E4428C-11A

S E R V I C E N O T E

E4428C Analog Signal Generator

Intermittent CPU boot-up and/or No display

Figure 2 U7 modification

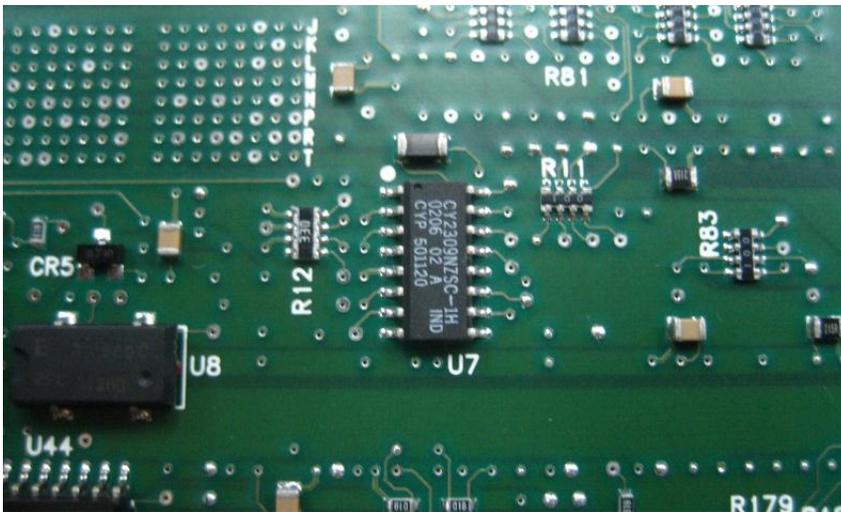
The clock buffer, U7 on the A12 CPU board, part number E4400-60500 may cause intermittent boot up and/or no display when the instrument is powered up. It is recommended that this modification is performed on any instrument within the serial numbers above that exhibits an intermittent boot-up and/or a blank display.

Using the appropriate soldering technique and ESD station, perform a modification on the U7 circuit on the A12 CPU board. Connect U7 pin 8 to 3.4V (wire pin 8 to pin 4) and connect U7 pin 9 to DCOM (wire pin 9 to pin 12).

1. Refer to E4428C/38C Service Guide for the A12 CPU removal procedure.
2. Refer to Figure 1 for U7.
3. Use 30 AWG wire for wiring pin 8 to pin 4, and pin 9 to pin 12 per Figure 2.
4. Re-install CPU and cover.
5. Run self test.
6. No calibration is required.
